1881 WESTLAKE DRIVE – BOAT DOCK REPLACEMENT

SP-2021-0349D

Hydrogeologic Reviewer

Watershed Protection Department

Rimrock(s)

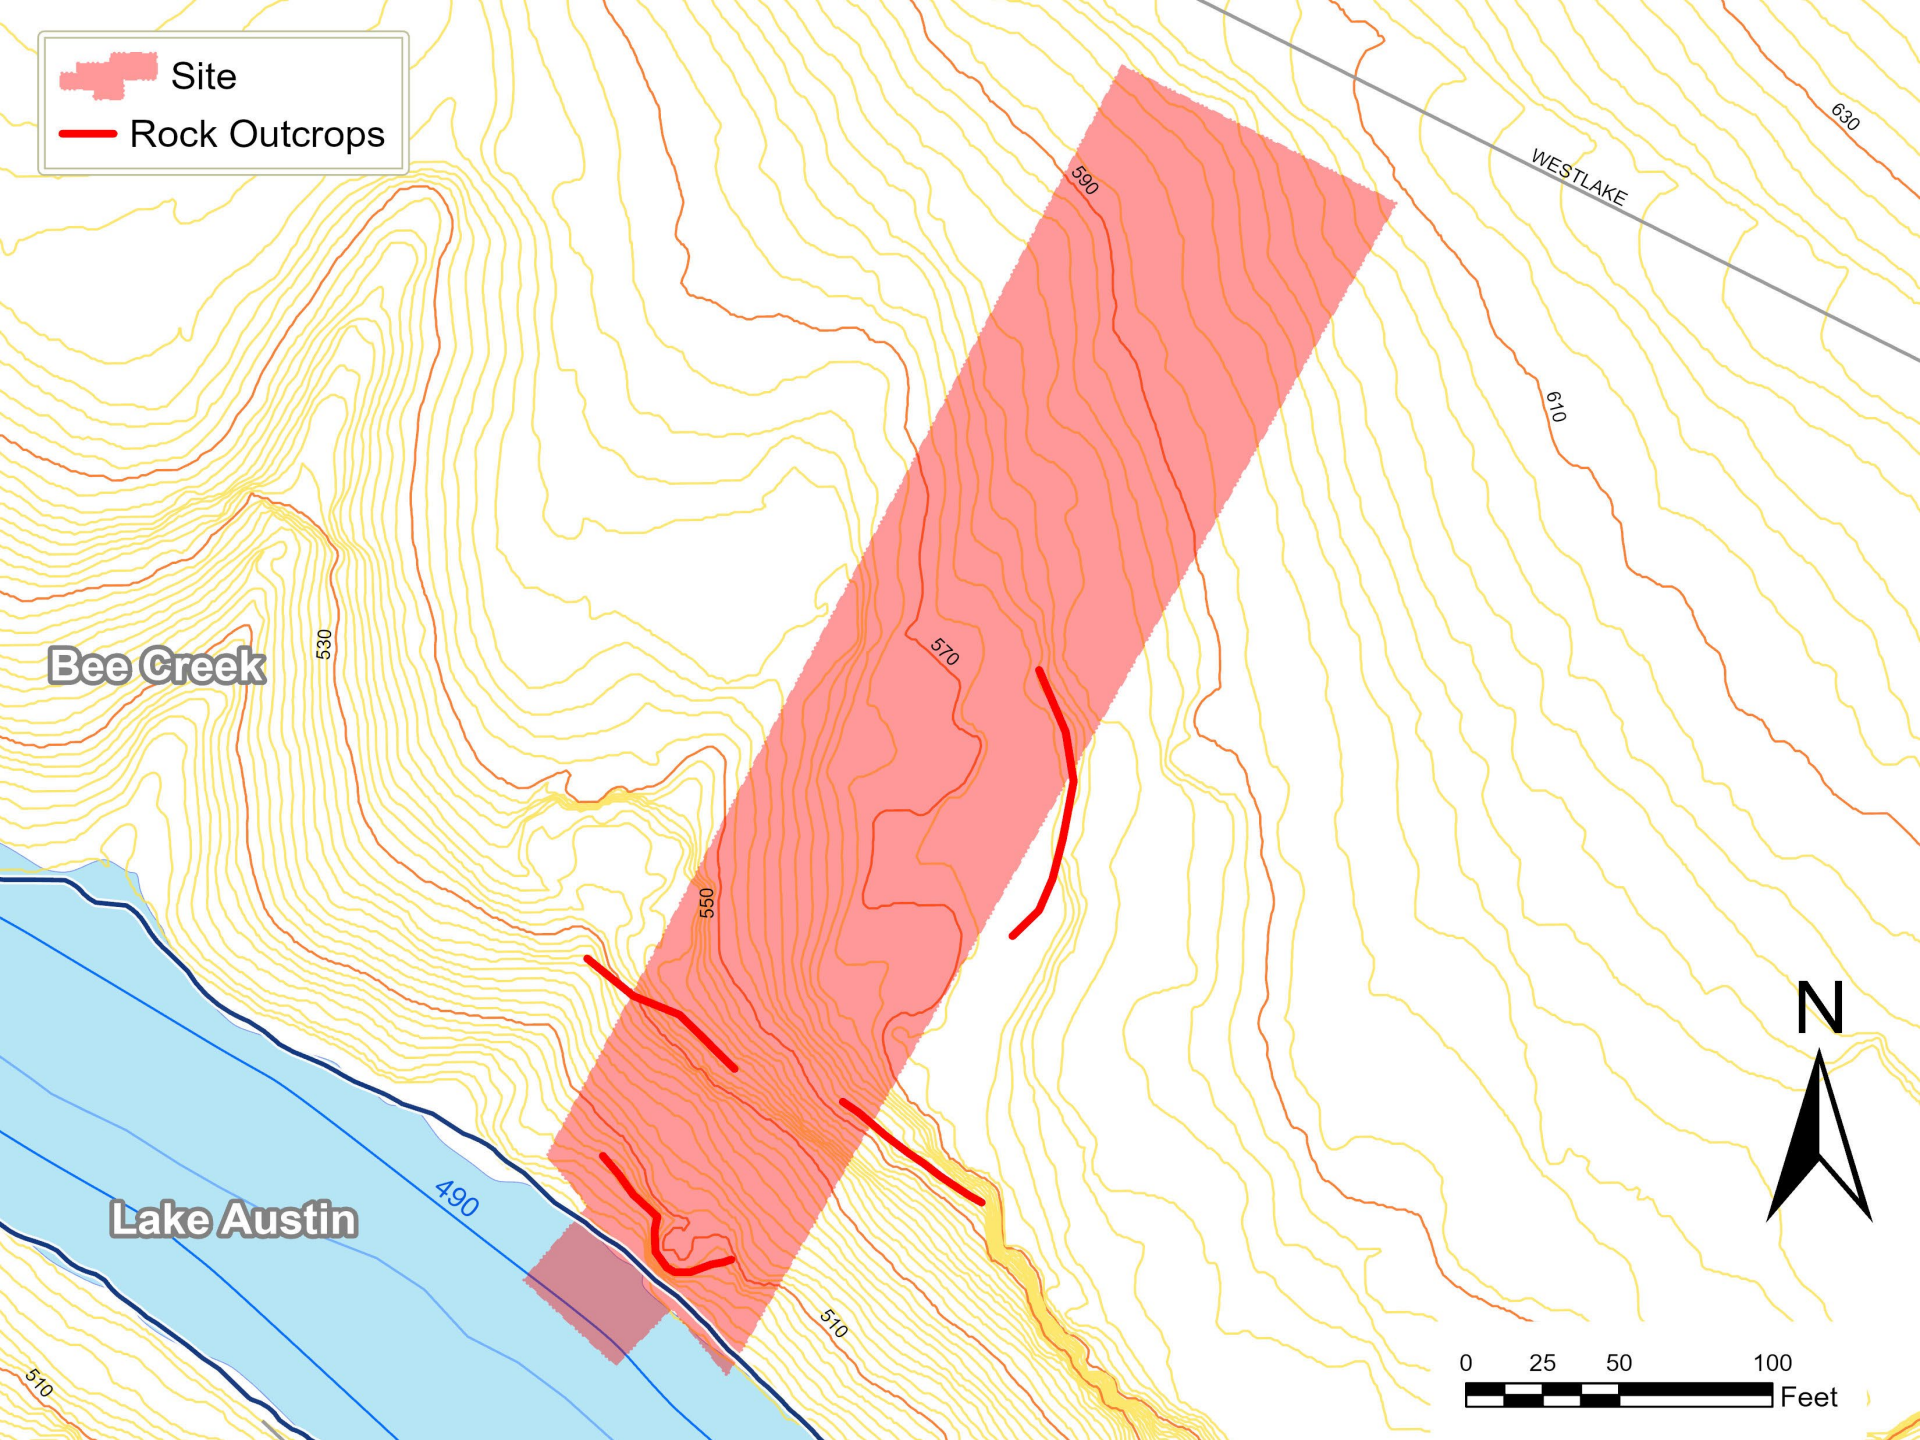
REQUEST TO VARY FROM LDC 25-8-
281(C)(2)(B) TO ALLOW CONSTRUCTION
WITHIN 150-FOOT OF CRITICAL
ENVIRONMENTAL FEATURE (CEF) BUFFERS.

FINDING OF FACTS HAVE BEEN MET.

STAFF RECOMMENDS THE APPROVAL OF THIS
VARIANCE WITH THE CONDITION THAT ALL
CONSTRUCTION BE COMPLETED BY BARGE.
